# CROSSROADS NORTH PRELIMINARY PLAN

LOCATED IN THE EAST 1/2 OF SECTION 8, T14S, R65W, OF THE 6th P.M., EL PASO COUNTY, COLORADO

# Prelim Plan V\_1 redlines.pdf Markup Summary 12-18-2020

# CROSSROADS NORTH PRELIMINARY PLAN / LANDSCAPE STANDARDS

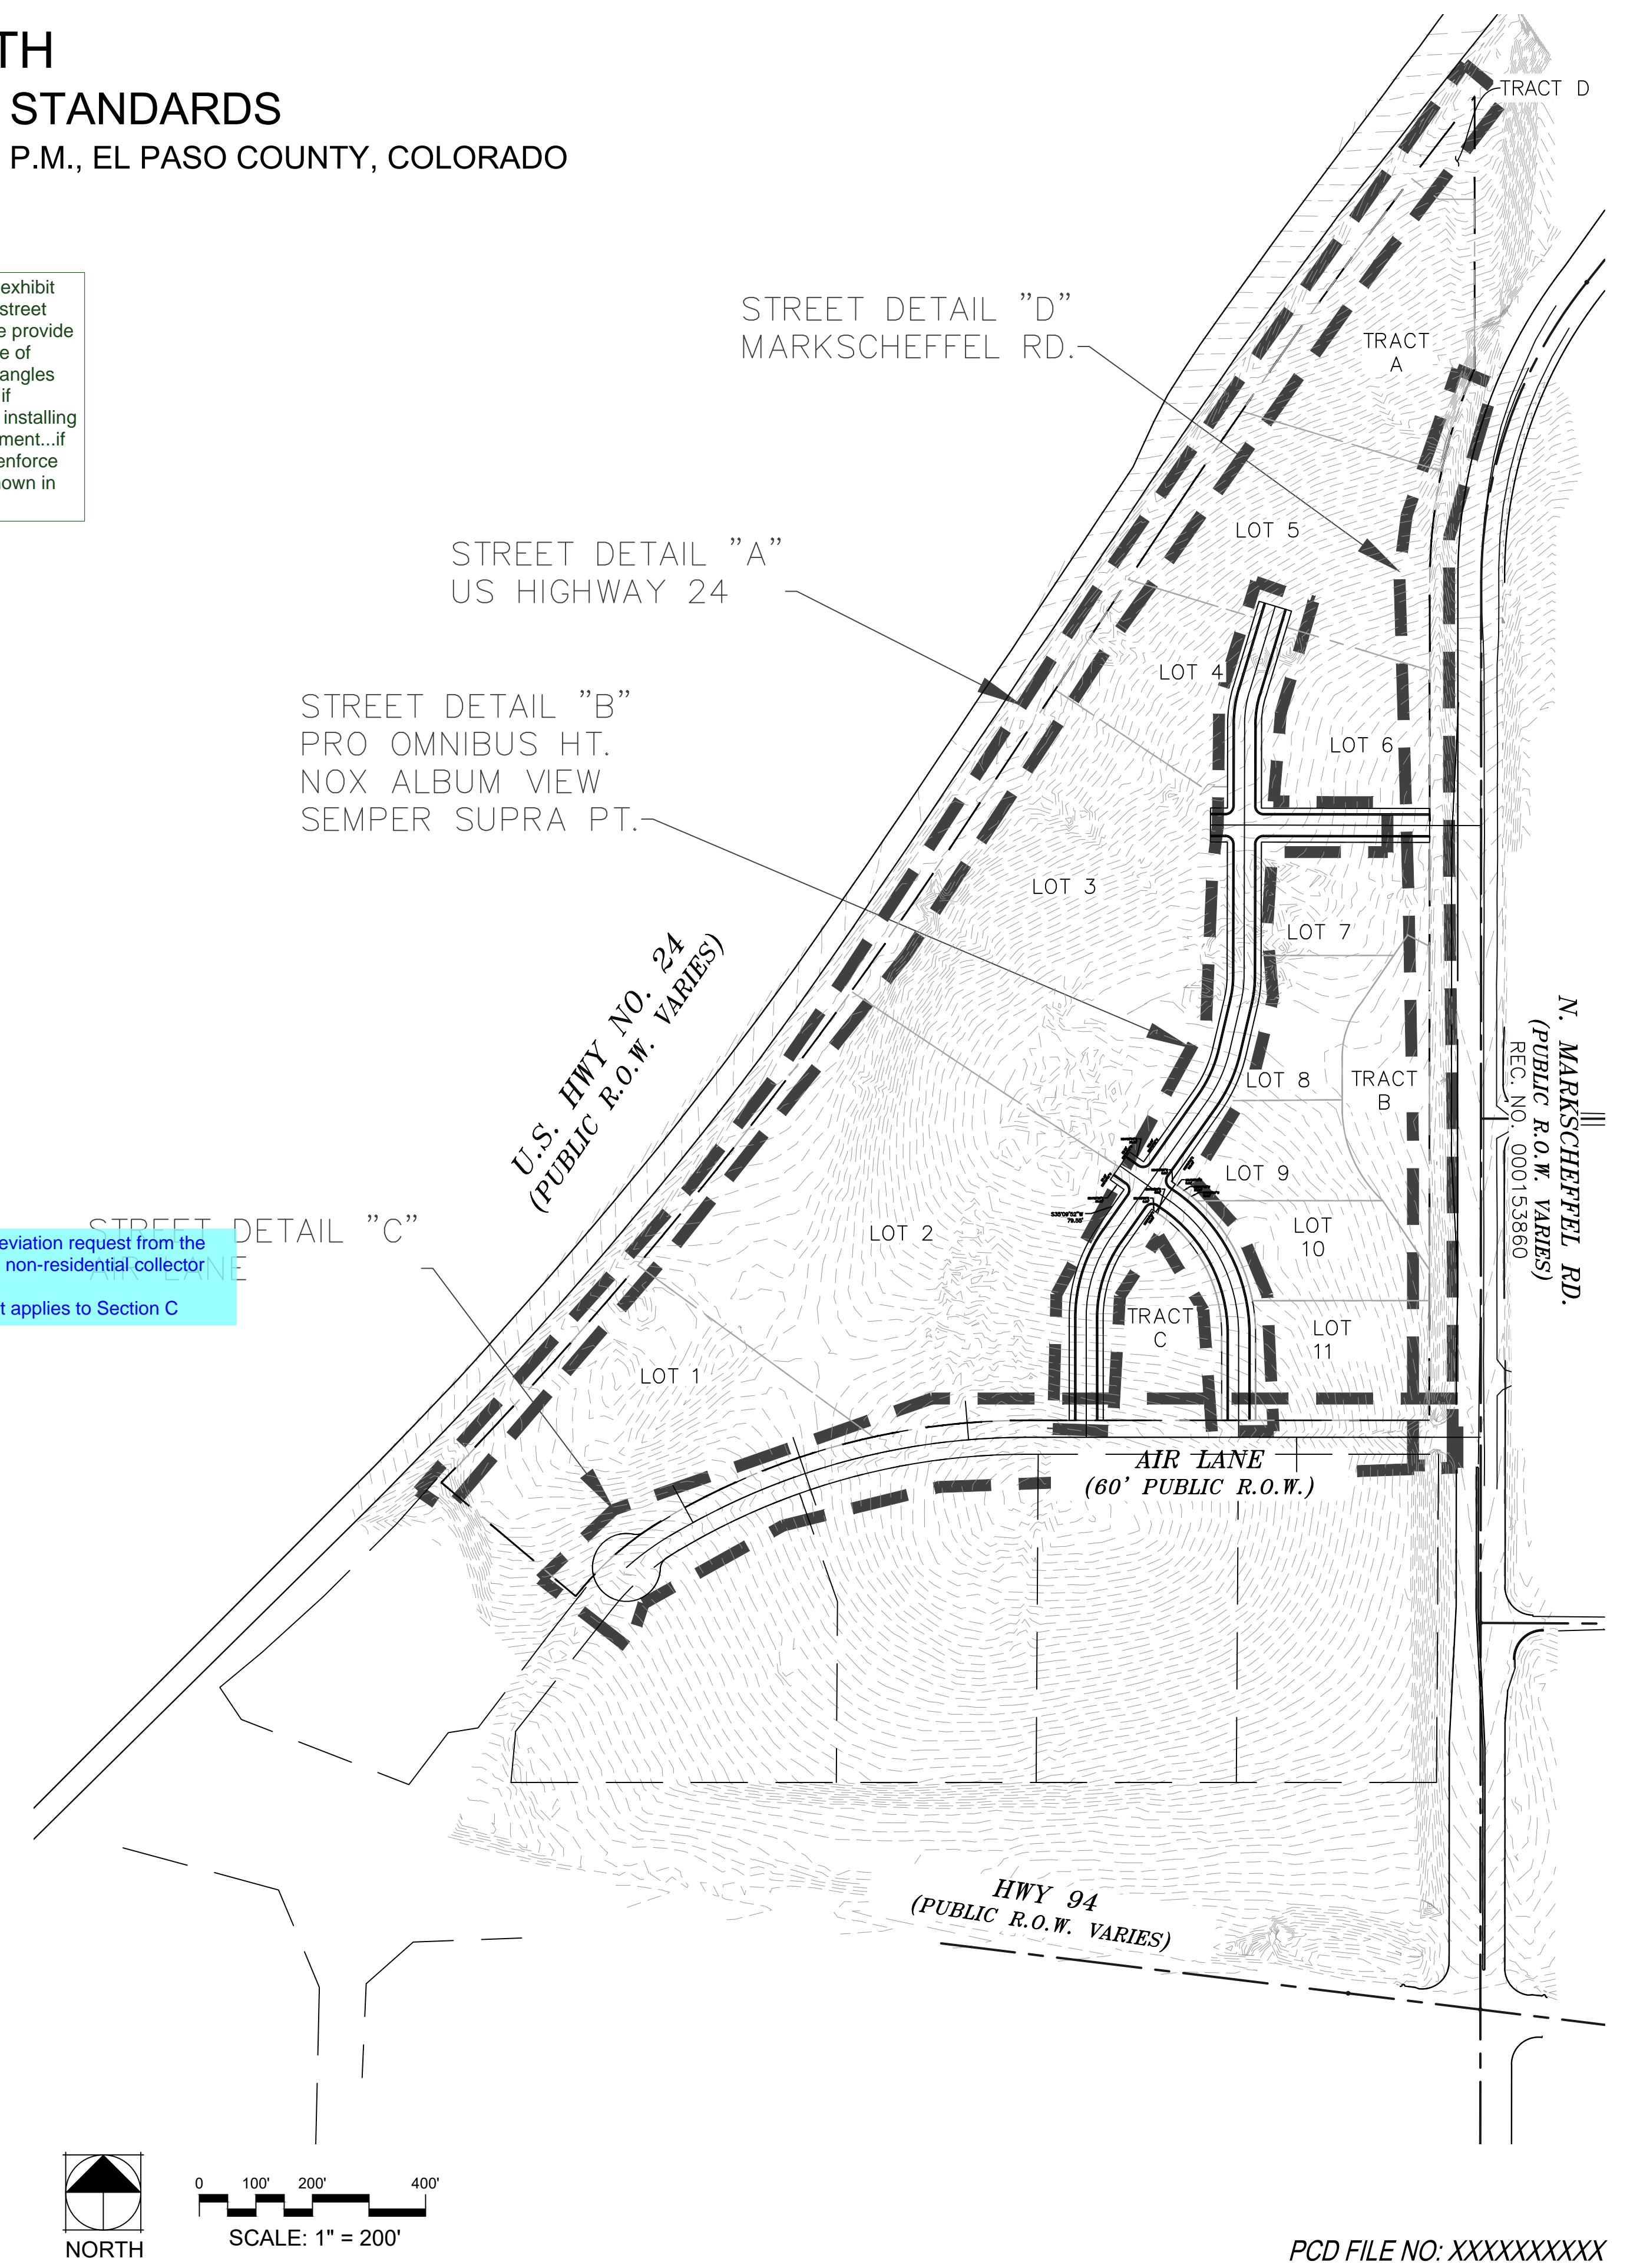
where is the exhibit showing the street trees? please provide and verify line of sight/sight triangles are shown...if Developer is installing with development...if you want to enforce standards shown in details

Change from ROW to either AUE or Tract. Adjust to include the entire section within the easement. Same comment applies to section C

Label lane widths and street/sidewalk cross slopes. Typical for sections B, C, & D

Update Sections B, & C by inserting the word "and" between street landscape.

This requires deviation request from the standard urban non-residential collector cross section. Same comment applies to Section C

Update callout and identify the standard EPC curb type (EPC Type A)
